PIC16(L)F1826/1827 Family Silicon Errata and Data Sheet Clarification

The PIC16(L)F1826/1827 family devices that you have received conform functionally to the current Device Data Sheet (DS41391D), except for the anomalies described in this document.

FIGURE 1: INSTRUCTION CYCLE DELAY CALCULATION EXAMPLE

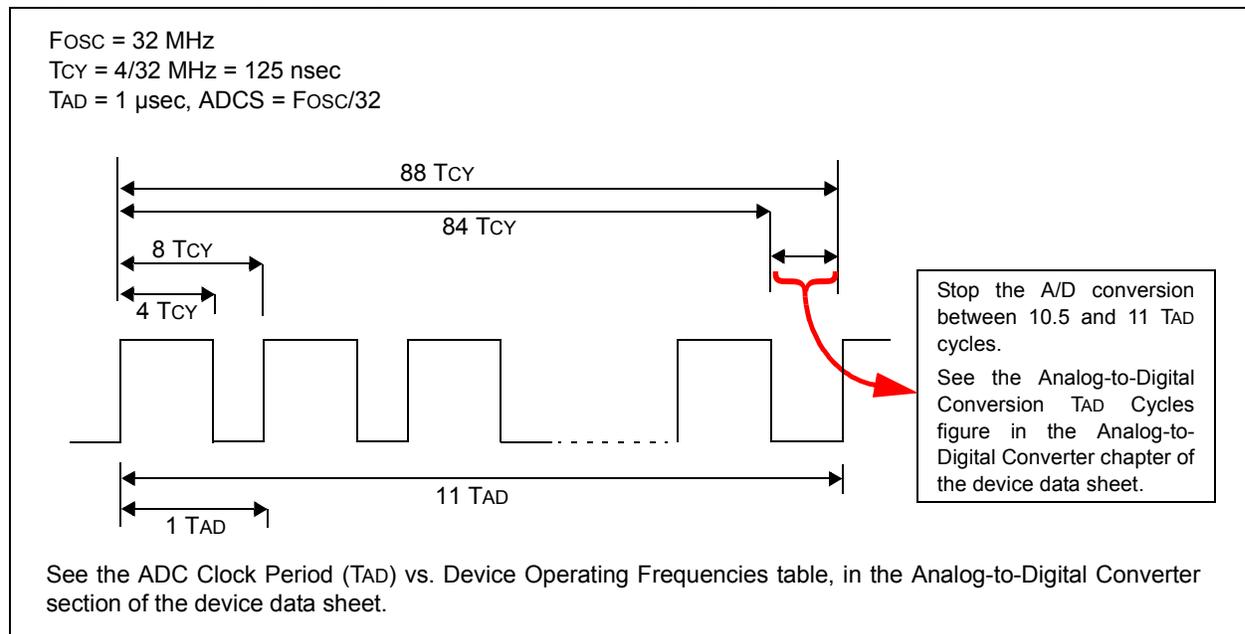
An ADC conversion may not complete under these conditions:

1. When F_{OSC} is greater than 8 MHz and it is the clock source used for the ADC converter.
2. The ADC is operating from its dedicated internal FRC oscillator and the device is not in Sleep mode (any F_{OSC} frequency).

When this occurs, the ADC Interrupt Flag (ADIF) does not get set, the $\overline{GO/DONE}$ bit does not get cleared, and the conversion result does not get loaded into the ADRESH and ADRESL result registers.

Method 3: This method is provided if the application cannot use Sleep mode and requires continuous operation at frequencies above 8 MHz. This method requires early termination of an ADC conversion. Provide a fixed time delay in software to stop the A-to-D conversion manually, after all ten bits are converted, but before the conversion would complete automatically. The conversion is stopped by clearing the $\overline{GO/DONE}$ bit in software. The $\overline{GO/DONE}$ bit must be cleared during the last $\frac{1}{2}$ TAD cycle, before the conversion would have completed automatically. Refer to Figure 1 for details.

In Figure 1, 88 instruction cycles (T_{CY}) will be required to complete the full conversion. Each TAD cycle consists of eight T_{CY} periods. A fixed delay is provided to stop the A/D conversion after 86 instruction cycles and terminate the conversion at the correct time as shown in the figure above.
